**MINUTES OF THE DEVELOPMENT APPEAL BOARD**  
**of the Town of Banff in the Province of Alberta**  
**Town Hall Council Chamber**  
**Thursday, September 27, 2010 at 9:00 am**

4.1. Appeal #02-10

# **Development Permit Application 10DP39**

403 Wolf and 228 Beaver Street

# Appeal 03-10

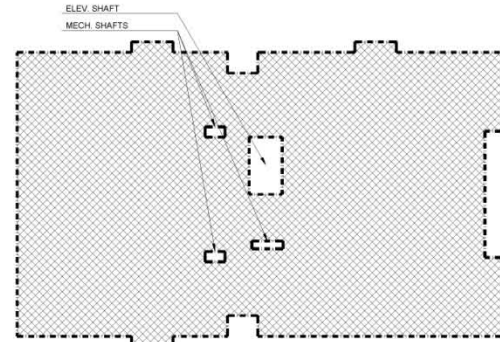
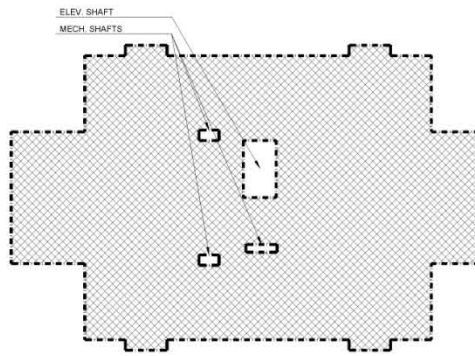
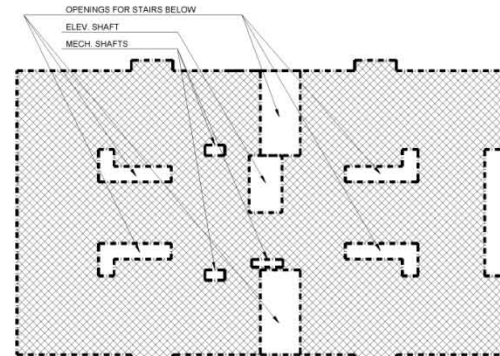
- The first concern of the appellant is with the size of building and the site coverage. The current approval is for a building that is 42 square feet above the allowable floor area ratio. The appellant believes there are some grey areas in the floor area calculations, for example elevator shafts have been exempted from calculations. The calculations should be redone.

- The spirit of the design guidelines have to do with visual mass. The enclosed porches currently approved for the building account for about 800 square feet. They could easily be converted into interior porches and so should be counted as part of the overall massing. If the porches were included in the floor area calculation, it would give a more accurate picture of the area being covered by the building.

- Interpretation of “Size of Building”
- Floor Area Ratio (FAR) calculations submitted by applicant reflect the current design exceeding maximum allowable (1.3) FAR by 42 square feet
- Given the pre-code review stage of this project and identified mechanical requirements (not shown), this seemed to be an issue best worked out through plan revisions

THE FLOOR AREAS HAVE BEEN RE-CALCULATED TO INCLUDE THE FIRE EXIT SHAFTS AS REQUESTED.

MAIN FLOOR AREA 4,942 S.F. (RE-CALCULATED)  
 MAIN FLOOR AREA 4,743 S.F. (D.P. APPLICATION)  
 ADDED FLOOR AREA 199 S.F.  
 HATCHED AREAS INCLUDED IN F.A.R. 'RE-CALCULATION'

SECOND FLOOR AREA 4,168 S.F. (RE-CALCULATED)  
 SECOND FLOOR AREA 3,859 S.F. (D.P. APPLICATION)  
 ADDED FLOOR AREA 309 S.F.

THIRD FLOOR AREA 4,546 S.F.  
 THIRD FLOOR AREA 4,743 S.F. (D.P. APPLICATION)  
 SUBTRACTED FLOOR AREA 197 S.F.
